HISTORIC PRESERVATION BOARD

HISTORIC PRESERVATION BOARD MEETING

**PUBLIC HEARING
35 COMMERCIAL STREET**

TO: Chair Pollard and Members of the Historic Preservation Board
FROM: Rob Wiener, Preservation Compliance Coordinator
DATE: December 29, 2020
RE: January 6, 2021 **Public Hearing** – Exterior Alterations and Additions

A1.05

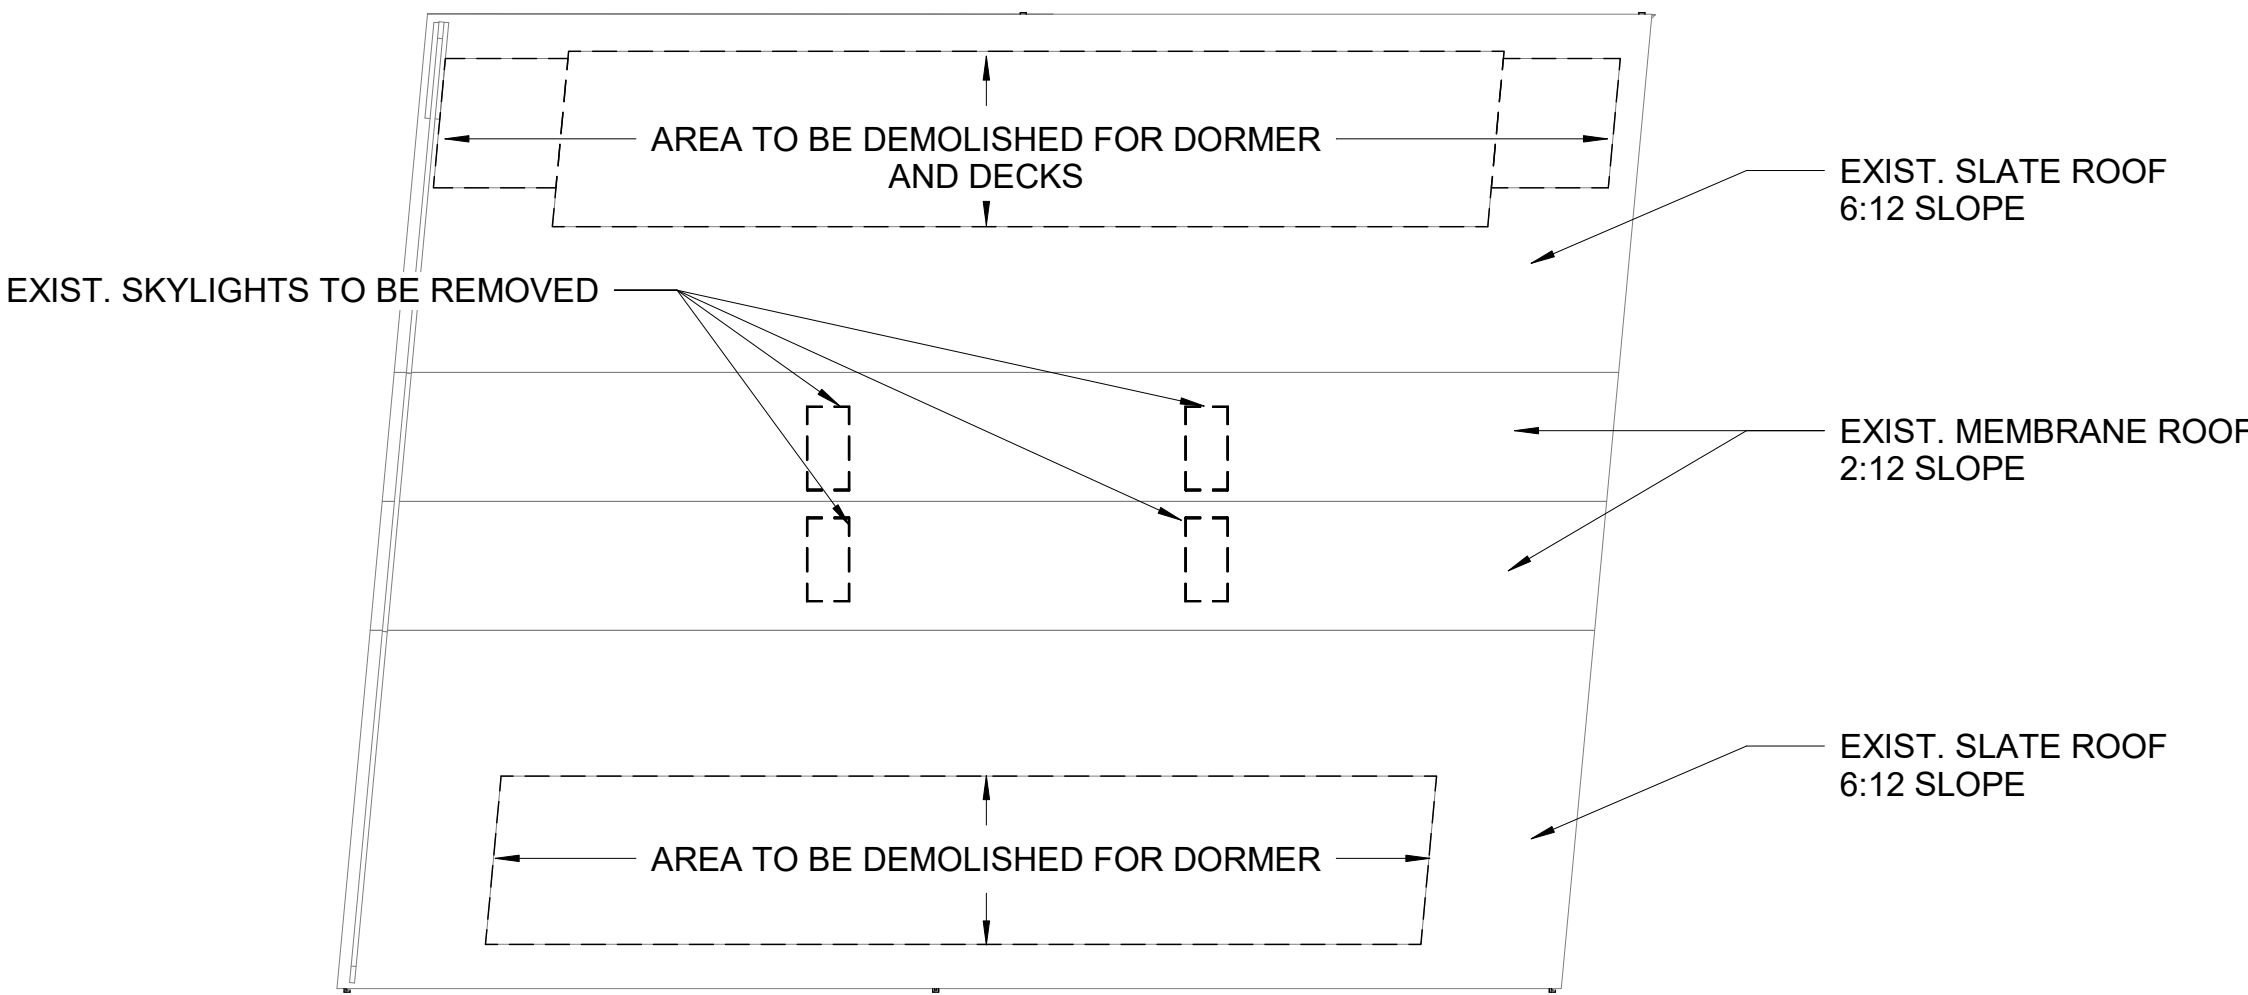
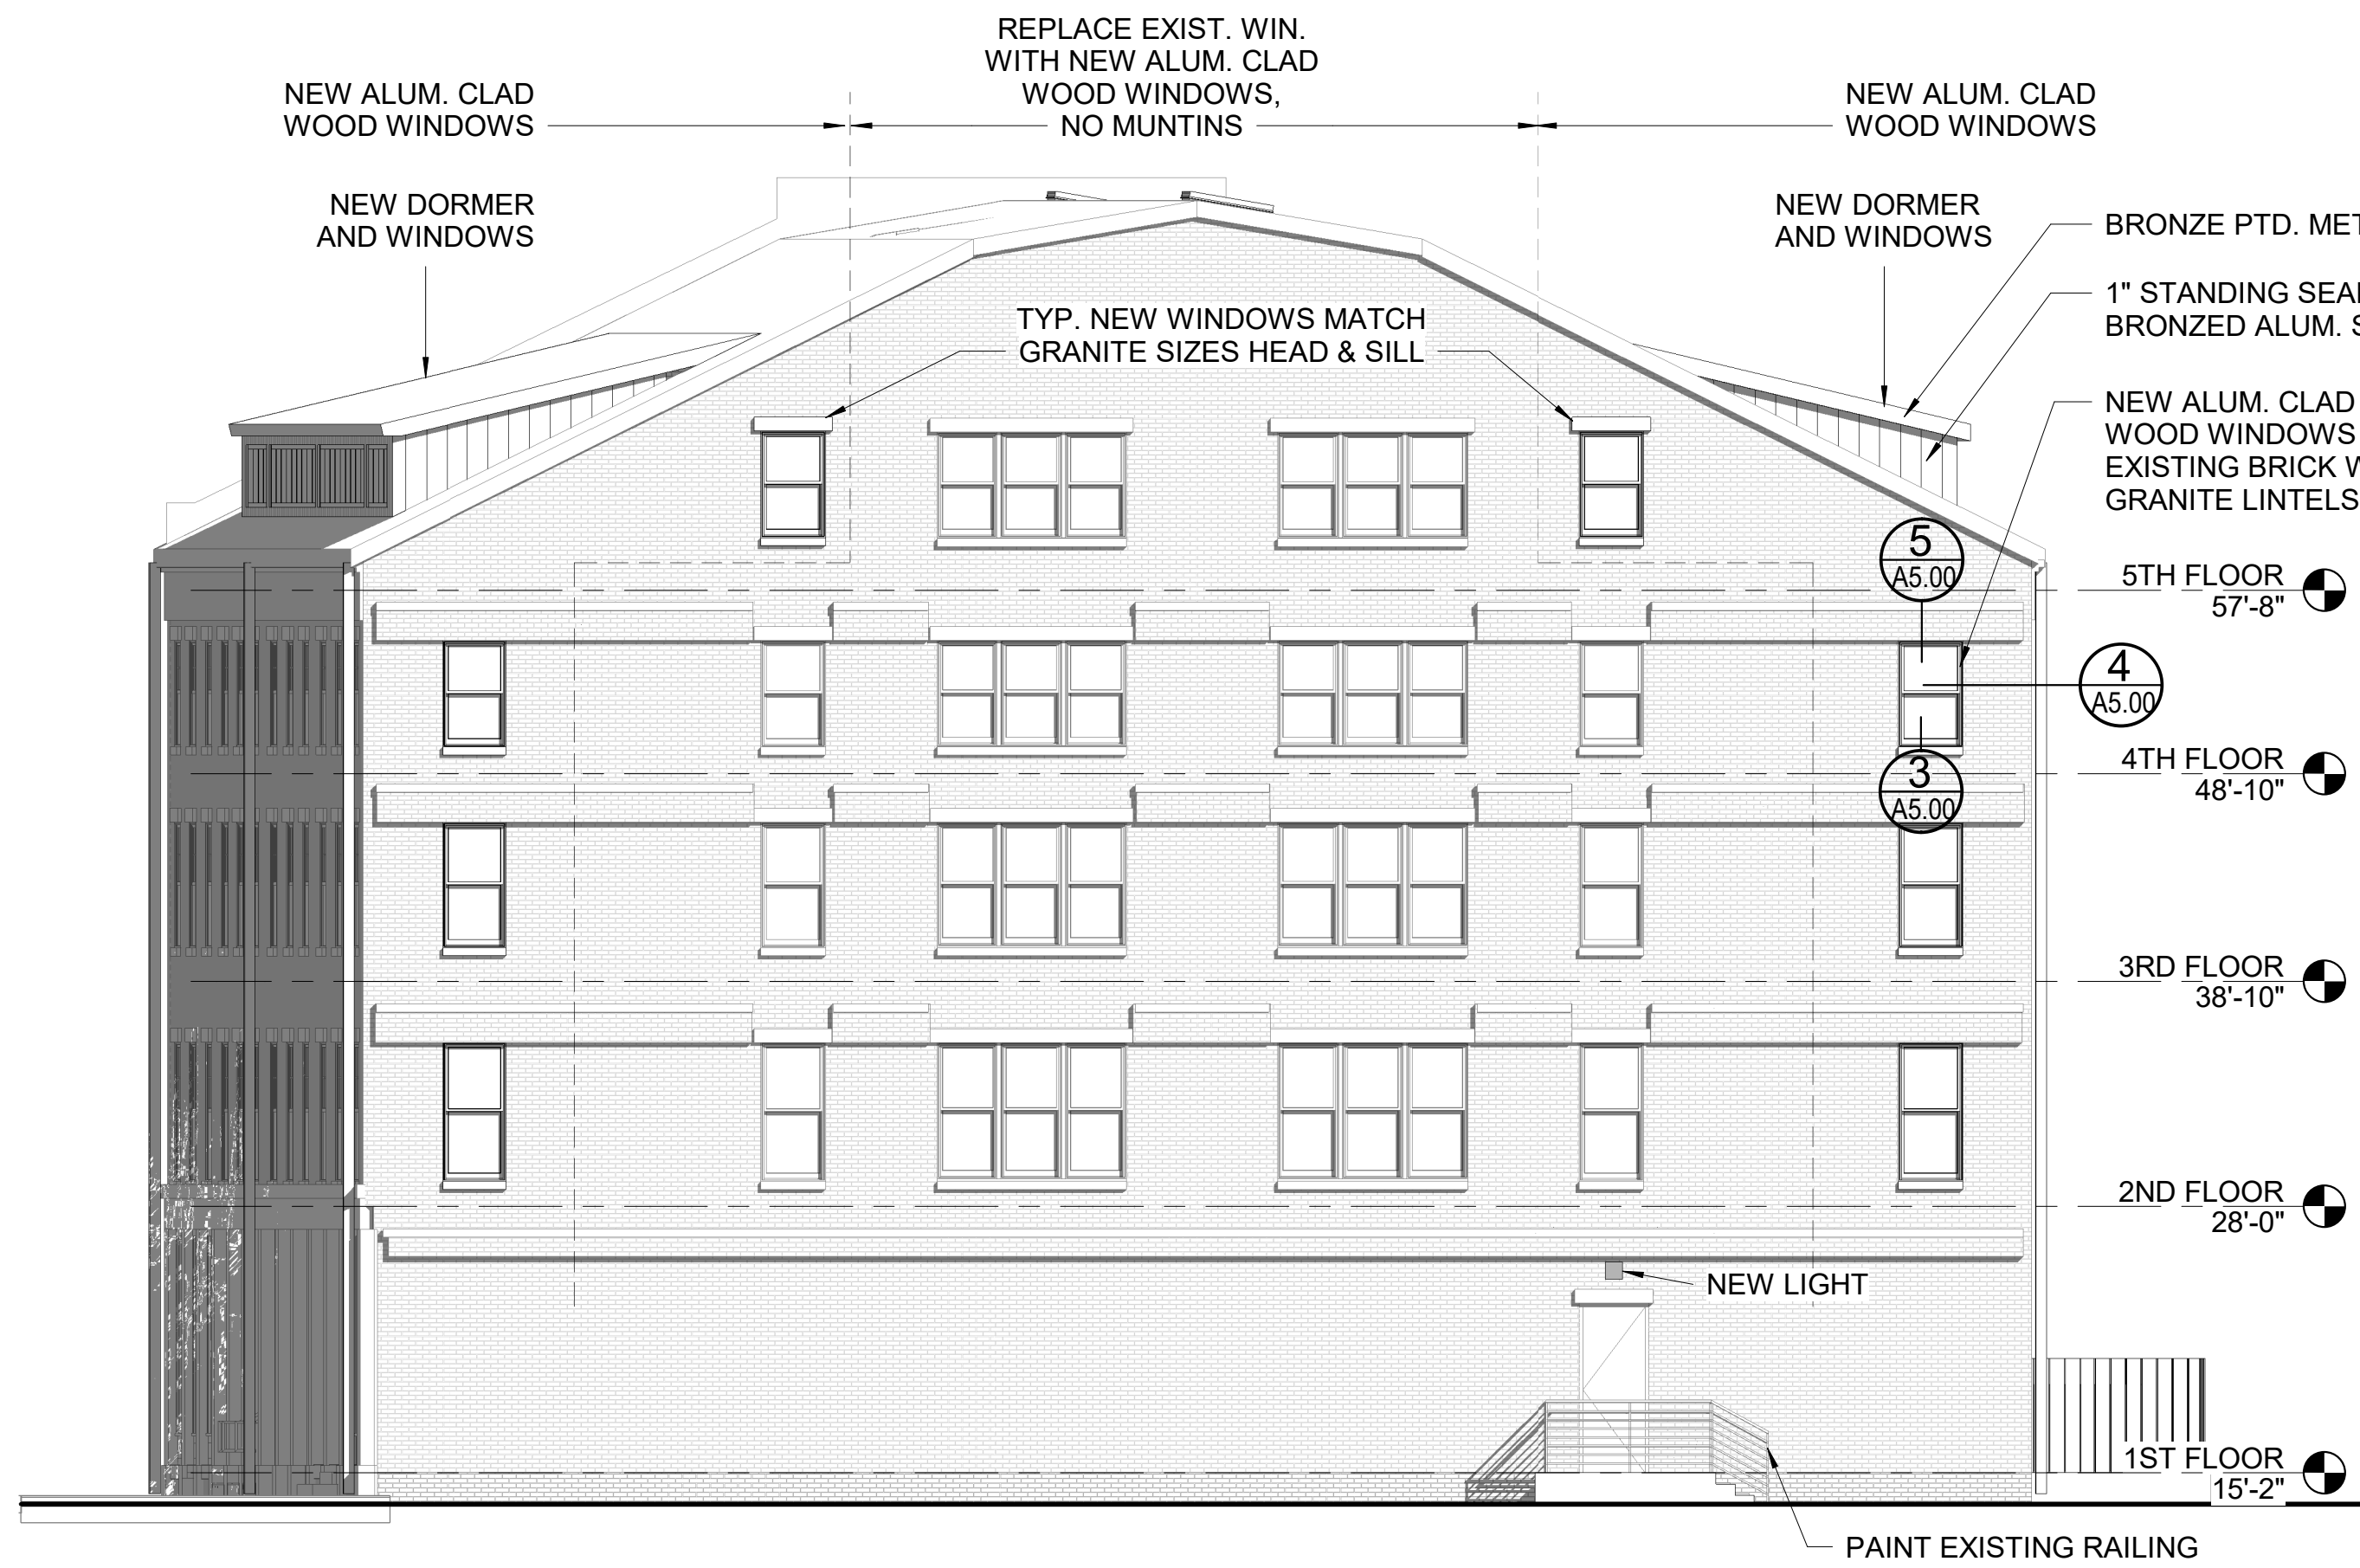
- *Skylights*
 - *Staff level review of the final choice for metal dormer siding, and masonry repair and repointing*
 - *More details and renderings will be necessary for a future, separate Board review of the site plan and landscaping on the west end of the building, next to Franklin Arterial.*

14. Four existing roof sky lights removed and add two new lower profile, Velux units now incorporated in roof plan and renderings.
